TANNOY V8/VX8/VXP8 and V12/VX12/VXP12 Driver Compatibility

Service Support

985-40000-00768 Rev.B
2018-01-09

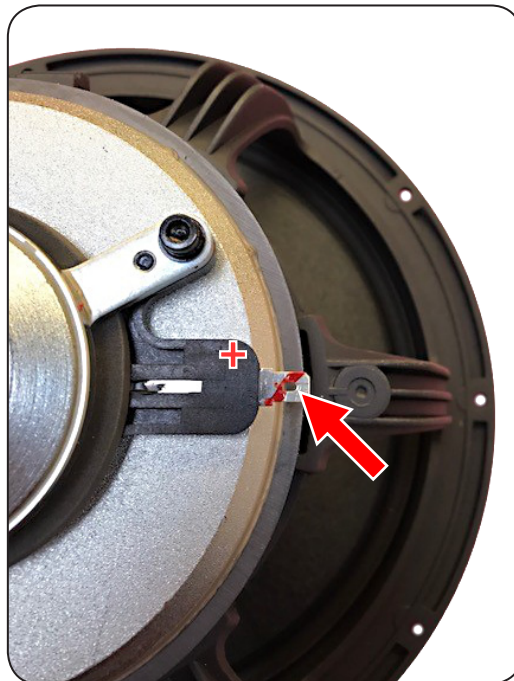
In order for the drivers to be compatible, the terminals of the HF Diaphragm must be swapped during the installation, following the procedure below:

1. Connect the Green wire (Negative) to the positive terminal of the diaphragm, as shown below.
2. Replace the connector at the end of the Yellow wire with one that is 4.8 mm (the correct size to match the negative terminal).
3. Connect the Yellow wire (Positive) to the negative terminal of the diaphragm, as shown below.
4. The wires for the driver will remain the same.

Yellow wire (Positive) to be connected to
negative terminal

Green wire (Negative) to be connected to the
positive terminal
